## Paper for Consideration by S-101PT3

## M\_CSCL and DataCoverage

<b>Submitted by:</b>	Australian Hydrographic Office
<b>Executive Summary:</b>	Amend the S-101 DCEG regarding the maximum number of DataCoverage features.
<b>Related Documents:</b>	S-57 Appendix B.1 Annex A (UOC) clause 2.2.6, S-101 Appendix A (DCEG).
<b>Related Projects:</b>

AU411142 – CSCL = 90000

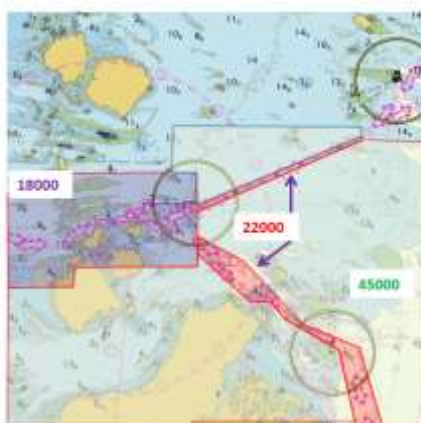
In the last 5 years or so the AHO started to include larger compilation scale areas in some ENC's (AU5 and AU4) to improve electronic navigation using ECDIS without any direct impact on paper charts. An example of this can be seen in the image above where a 1:22000 M\_CSCL was created along the TWR up in Torres Strait (Great Barrier Reef). This area includes more soundings and detailed standard contours and gives more room for ships to visualize crossings, etc.
